H11718

DESCRIPTIVE REPORT

Registry No. H11718

General Locality Akutan Pass

Figure 2 Profile of 2G03-TIE01

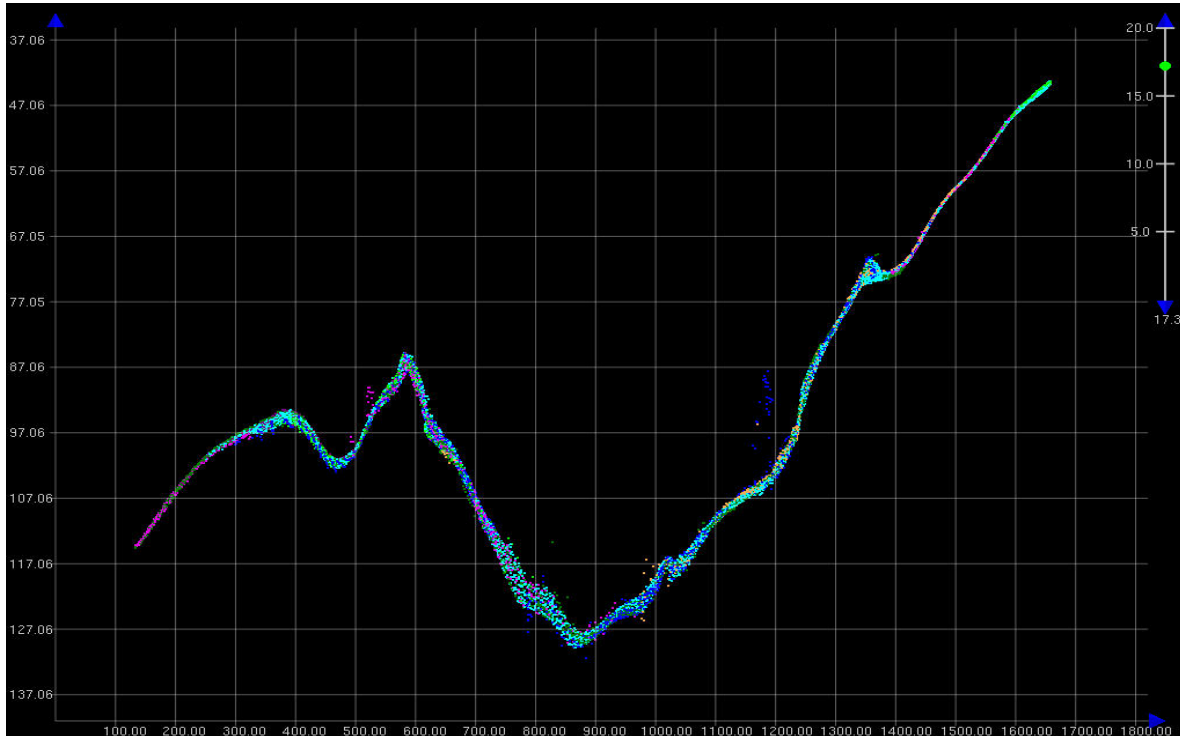
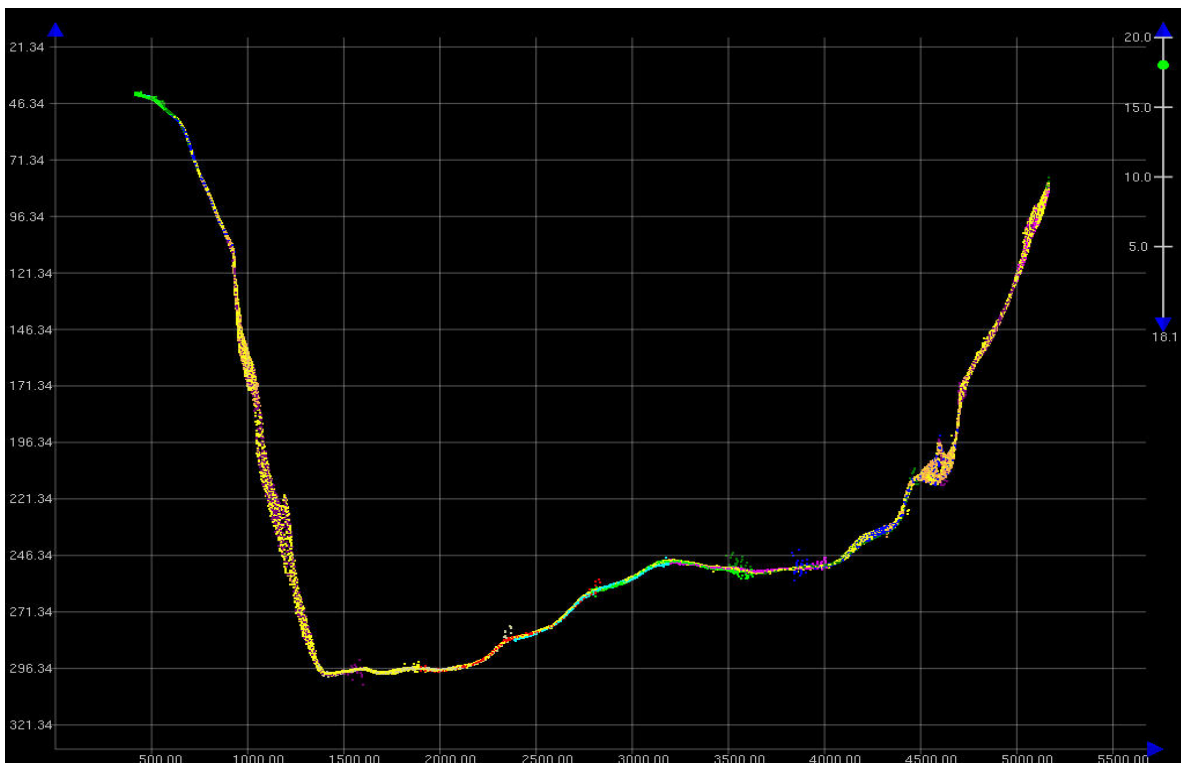
The majority of QC Reports fall well within the required accuracy specifications. However, beams that fall below the 95 percent confidence level in the QC report are associated with areas and conditions illustrated below. It should be noted that these locations are in agreement with the surrounding adjacent lines and are considered well within the required specifications. ¹

The majority of beams that fall below the 95 percent confidence level are located in areas having extremely steep slopes and/or rocks². Figures 2 and 3 below provide examples.

¹ Concur.

Figure 4 H11718 Uncertainty DTM

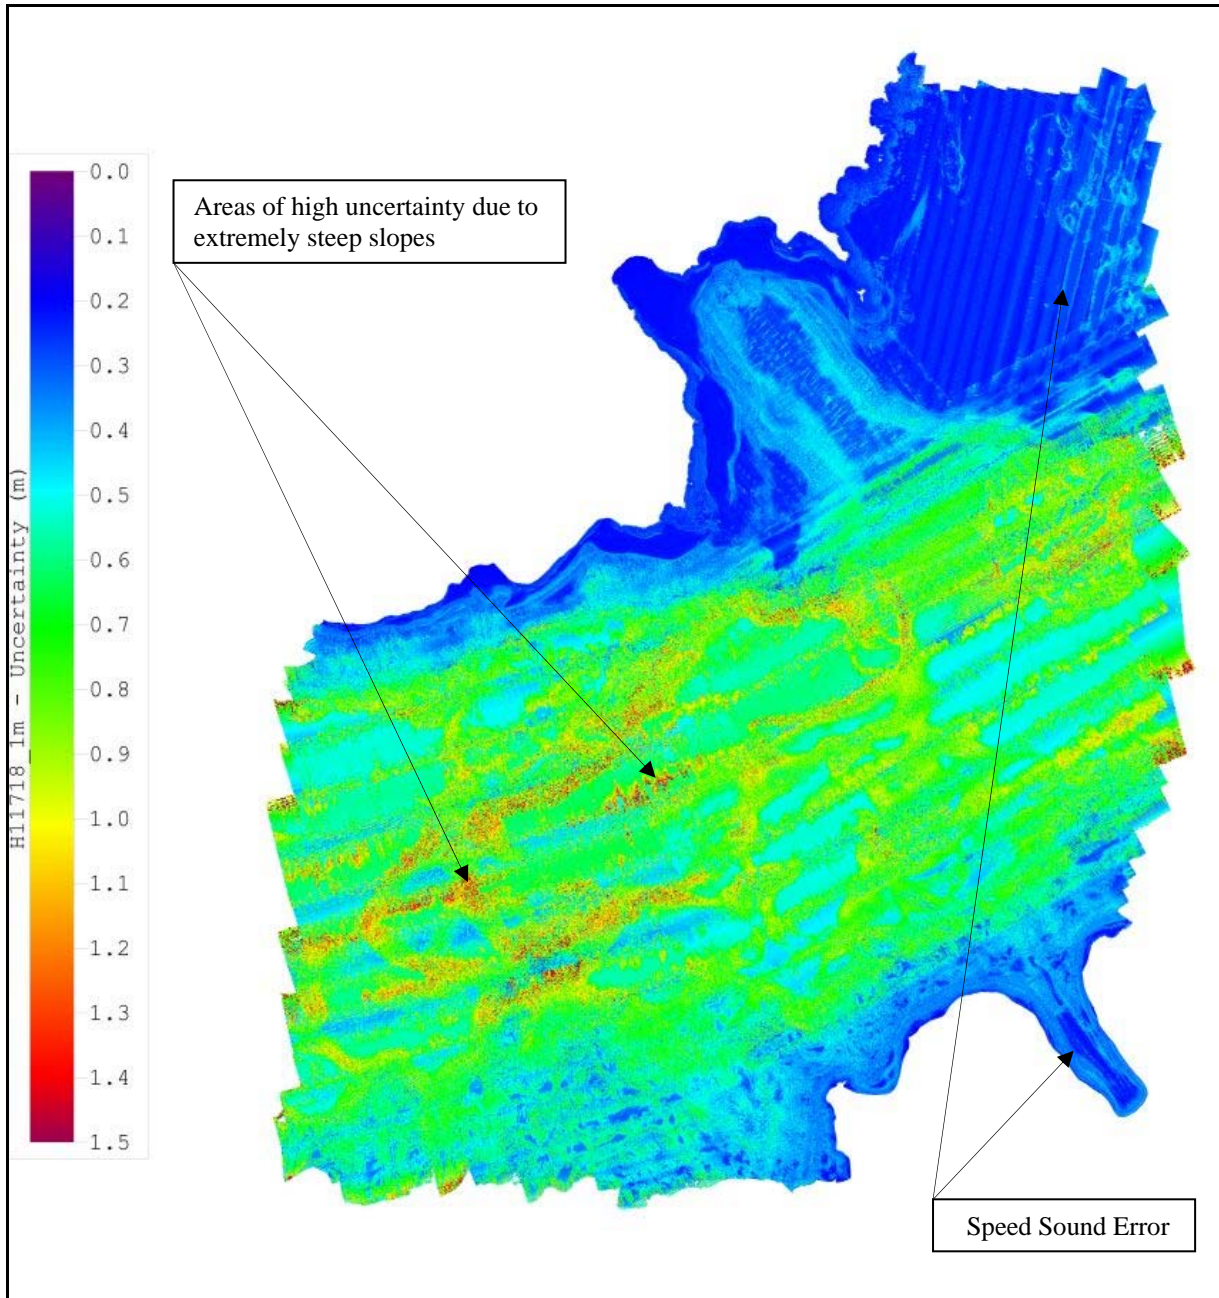
The majority of H11718 had an uncertainty of about 0.20 to 0.50 meters, except for the deep water areas having extremely steep slopes or deemed to be rocky, where values ranged from 0.60 meters and greater. No uncertainty values were greater than the IHO level Order 1.³

³ Concur.

Figure 5 H11718 Survey Junctions

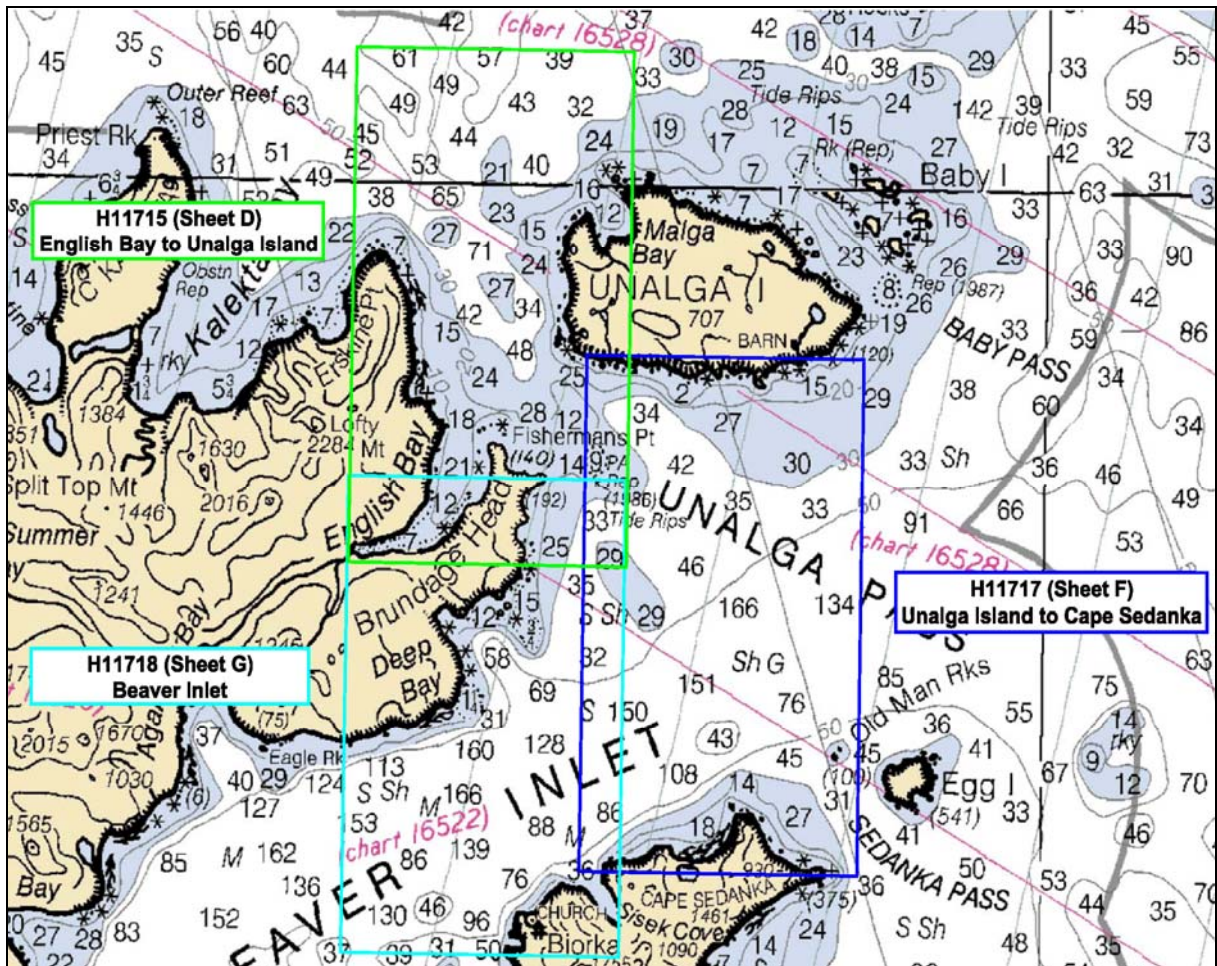
H11718 (Sheet G) junctions with⁴:

The surveys are in agreement along their common borders. The agreement was noted in the field using the CARIS CUBE surfaces during subset cleaning. The conformity is also apparent in the final combined BASE surfaces.⁵

⁴ A common junction was created between H11718 and surveys H11715 and H11717.

⁵ Concur.

Figure 6 H11718 Chart Comparison (Chart 16522)

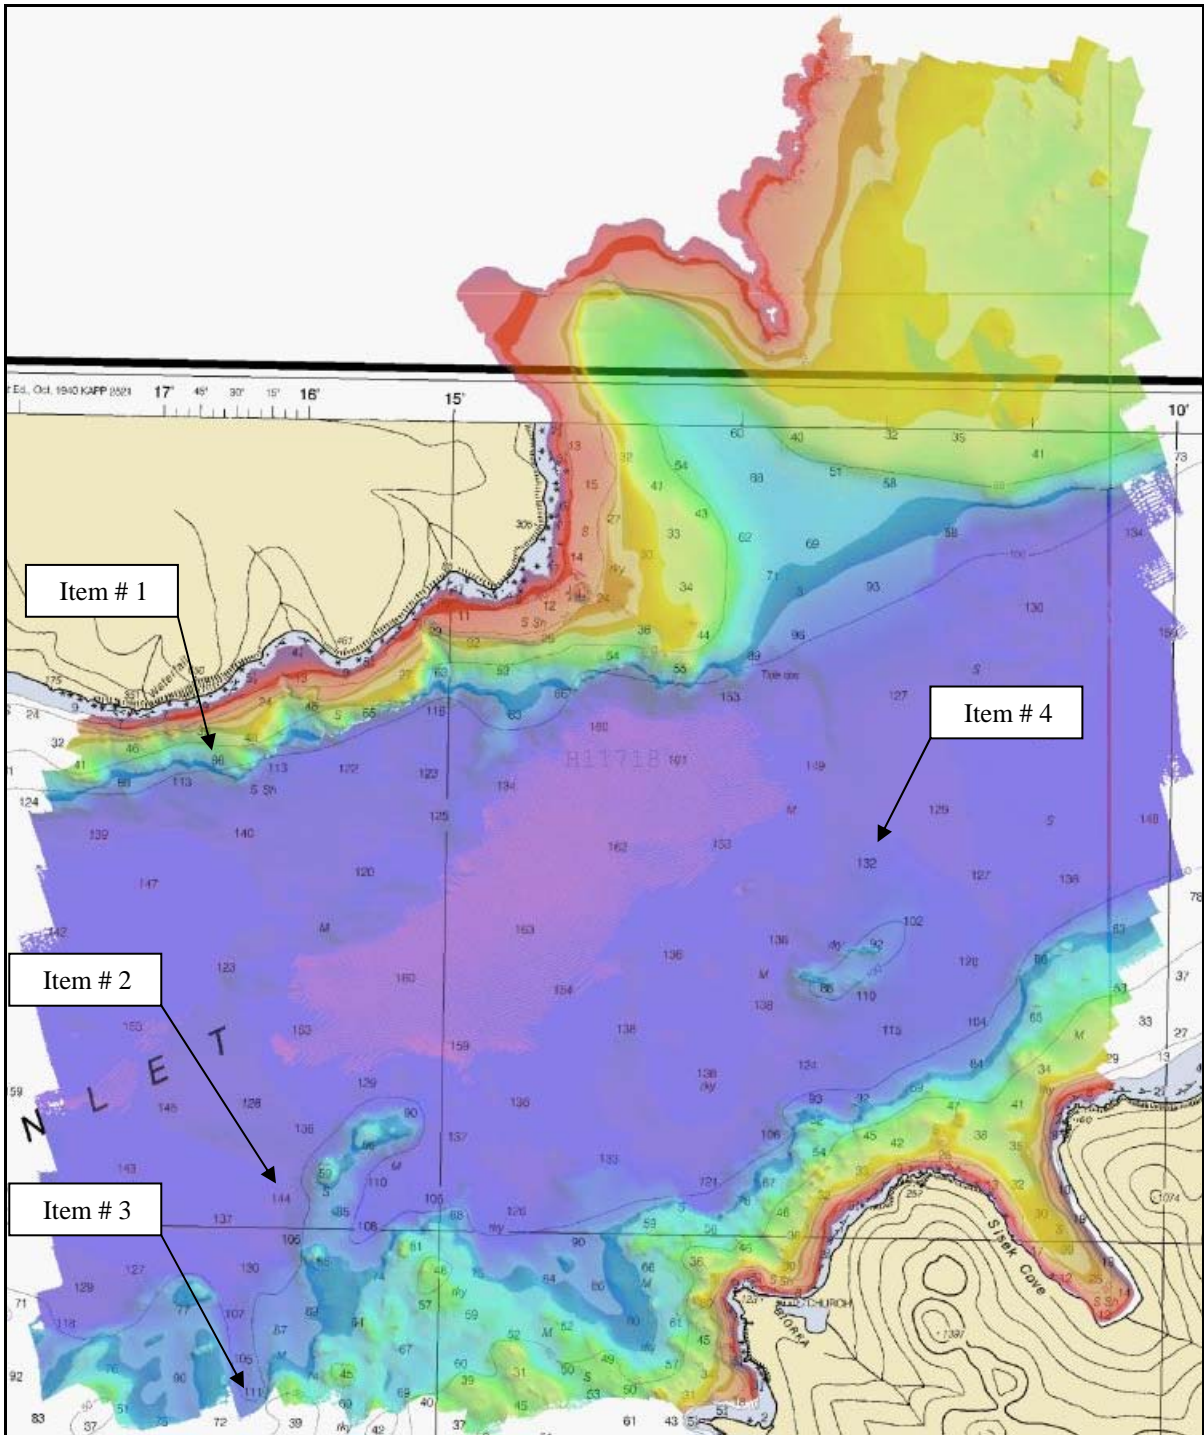
In general, the soundings from chart 16522 coincide with the soundings from H11718 to within 1 to 5 fathoms; areas that do vary to any degree are as follows:

- Item # 1: Hydrographic survey H11718 revealed a depth of 62 fathoms in the vicinity of a 86 fathom sounding on chart 16522 located at 53°51'54" N, 166°16'35" W. This comparison can also be found on Chart 16528, Item # 8. This area was surveyed with 100% multibeam coverage. The shoaling is centered in the area depicted below.

- Item # 2: Hydrographic survey H11718 revealed a depth of 132 fathoms in the vicinity of a 144 fathom sounding on chart 16522 located at 53°50'07" N, 166°16'04" W. This comparison can also be found on Chart 16528, Item # 6. This area was surveyed with 100% multibeam coverage. The shoaling is centered in the area depicted below.

- Item # 3: Hydrographic survey H11718 revealed a depth of 95 fathoms in the vicinity of a 111 fathom sounding on chart 16522 located at 53°49'20" N, 166°16'15" W. This comparison can also be found on Chart 16528, Item # 5. This area was surveyed with 100% multibeam coverage. The shoaling is centered in the area depicted below.

- Item # 4: Hydrographic survey H11718 revealed a depth of 116 fathoms in the vicinity of a 132 fathom sounding on chart 16522 located at 53°51'32" N, 166°12'04" W. This comparison can also be found on Chart 16528, Item # 2. This area was surveyed with 100% multibeam coverage. The shoaling is centered in the area depicted below.

¹¹ The HCell was compiled to chart 16528. Chart 16522 at the same scale partially falls in the survey area. Discrepancies exist between the charted features of 16528 and 16522, mainly in the inshore areas of the charts, possibly due to the most recent RSD shoreline not being fully applied to 16522. Features falling within the survey area were de-conflicted and recommendations made in the HCell, however many of the features inshore of the survey were not addressed. Recommend a review of the charted features on the two charts be conducted.

¹⁴ Concur generally with the hydrographers sounding comparison unless otherwise noted.

Figure 7 H11718 Chart Comparison (Chart 16528)

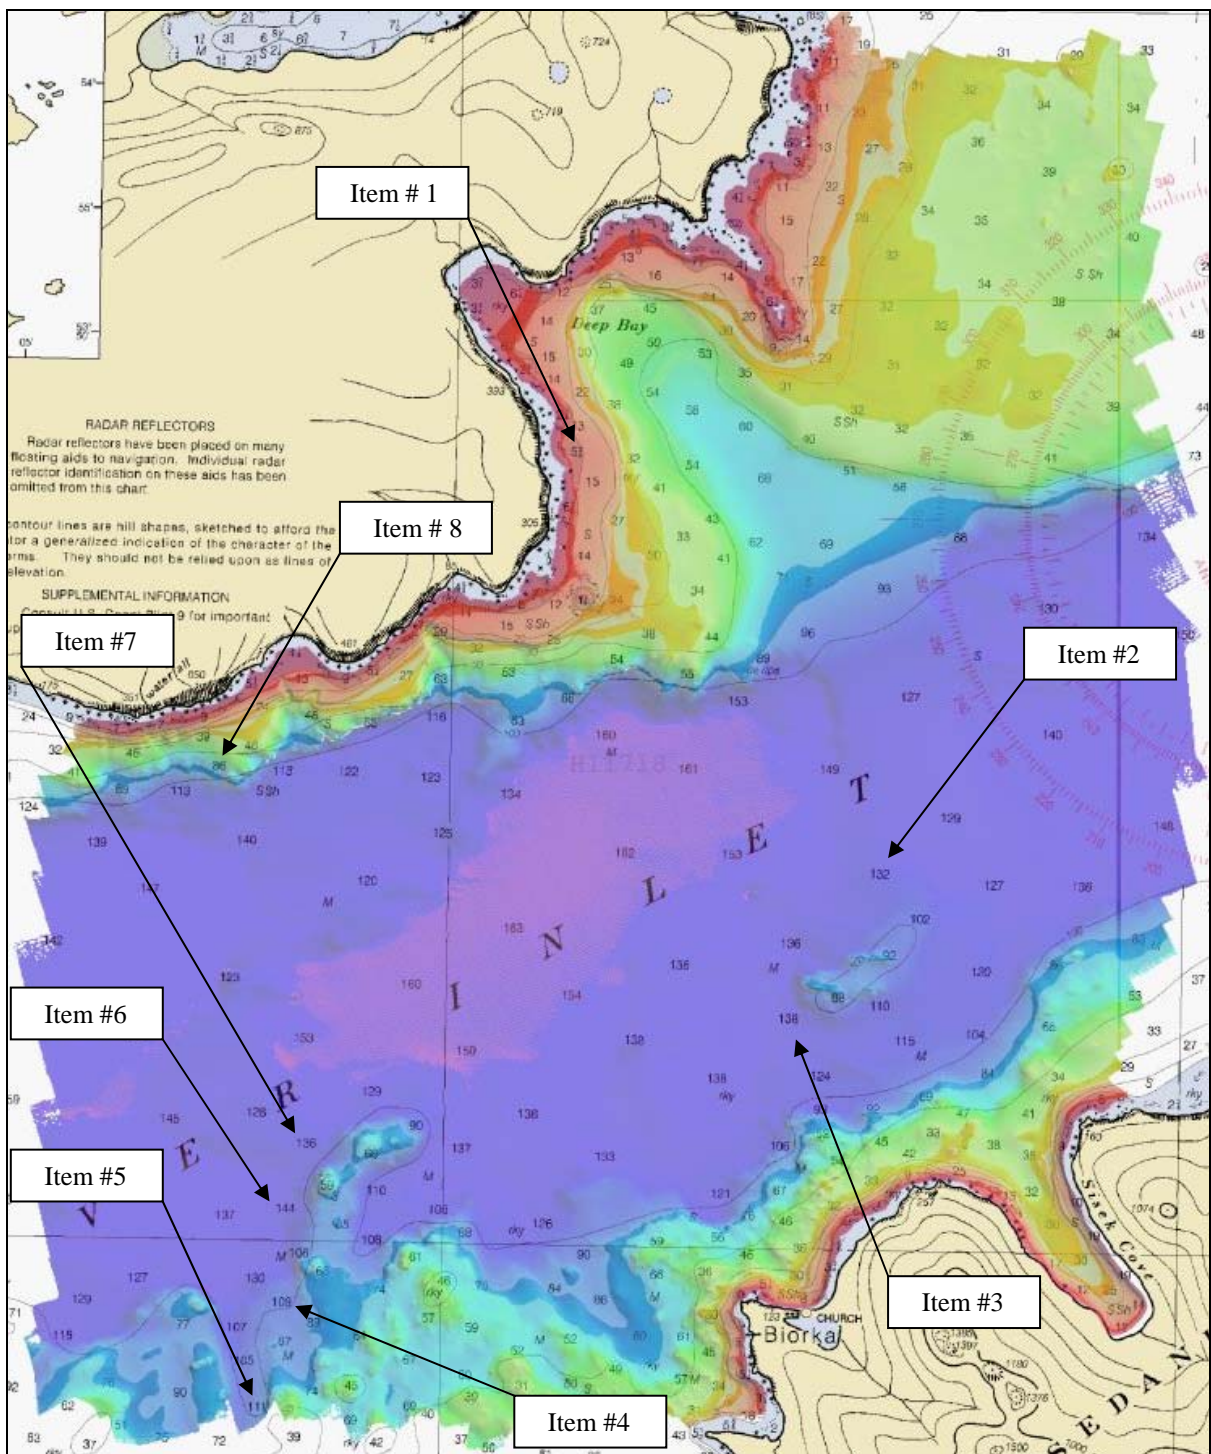
- Item # 1: Hydrographic survey H11718 revealed a depth of 13 fathoms in the vicinity of a 5 ¾ fathom sounding on chart 16528 located at 53°53'11" N, 166°14'09" W. This area was surveyed with 100% multibeam coverage.¹⁵

¹⁵ A 2.500 fathom rock present near charted 5 $\frac{3}{4}$ fathom sounding. Chart per HCell

Figure 9 H11718 Electronic Chart Comparison (US3AK61M)

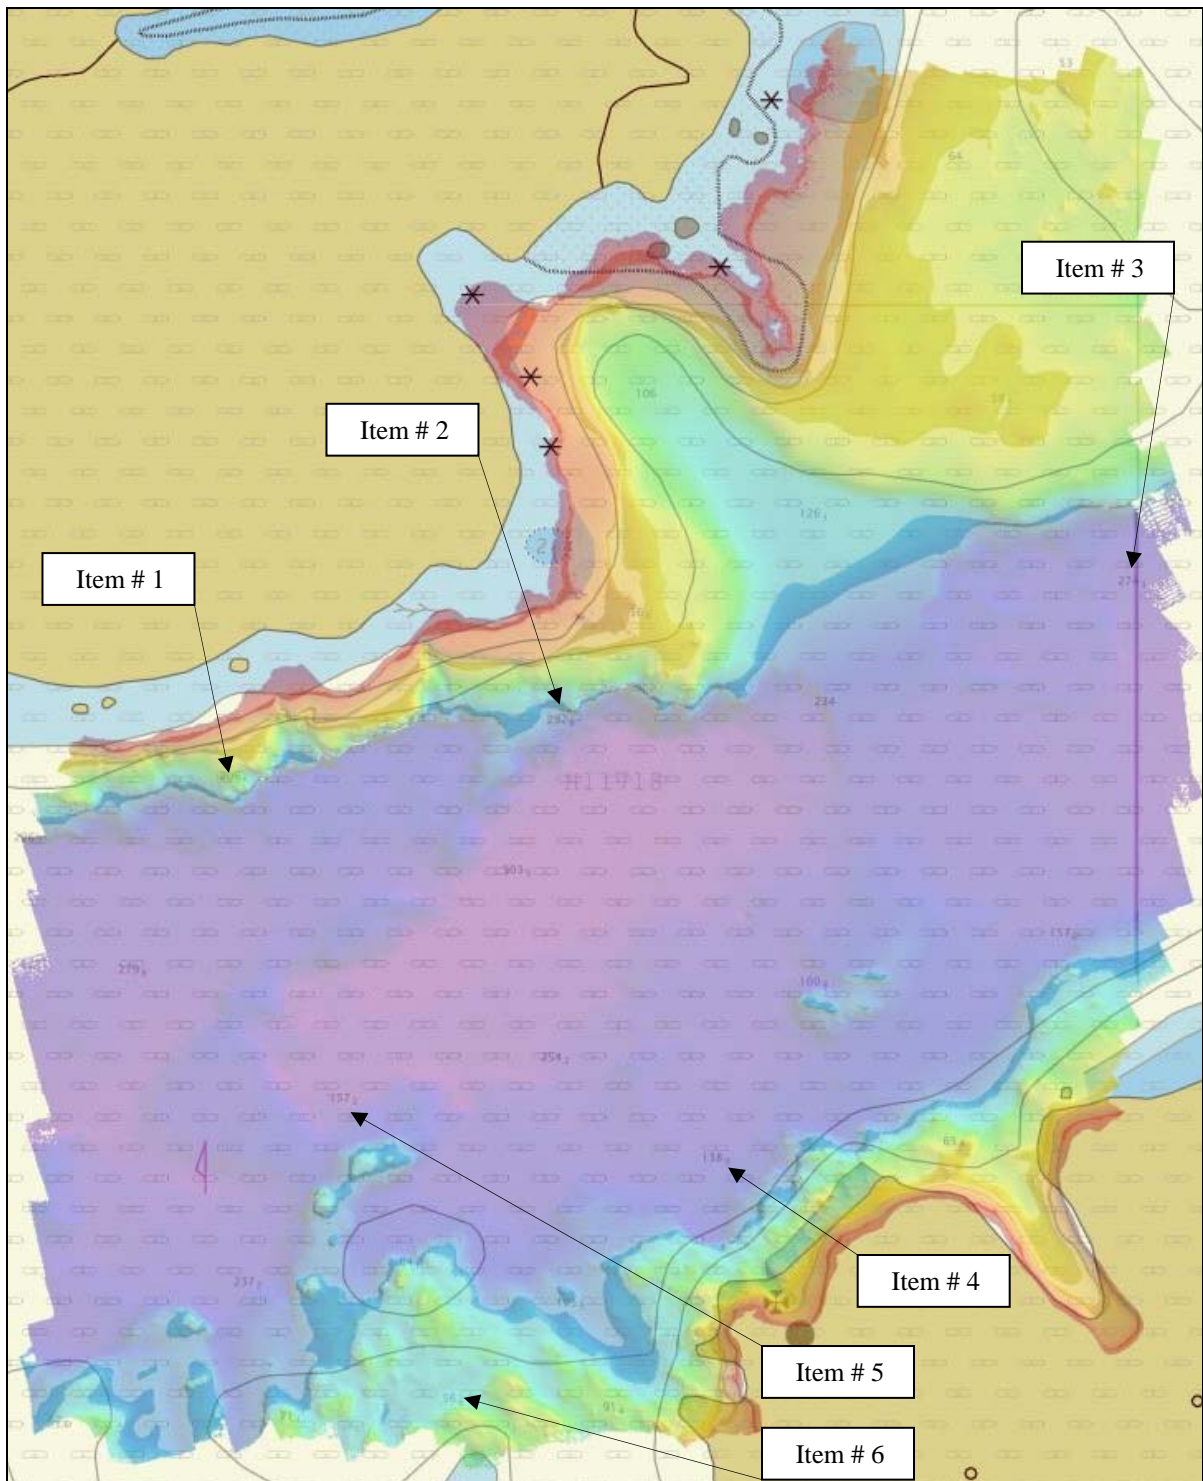
In general soundings from chart US3AK61M coincide with the soundings from H11718 to within 5 to 15 meters; areas that do vary to any degree are as follows¹⁶:

- Item # 1: Hydrographic survey H11718 revealed a depth of 82.5 fathoms in the vicinity of a 206.6 fathom sounding on chart US3AK61M located at 53°51'55" N, 166°16'26" W. This area was surveyed with 100% multibeam coverage. The shoaling is centered in the area depicted below.

¹⁶ All units on items 1-6 should read meters rather than fathoms.
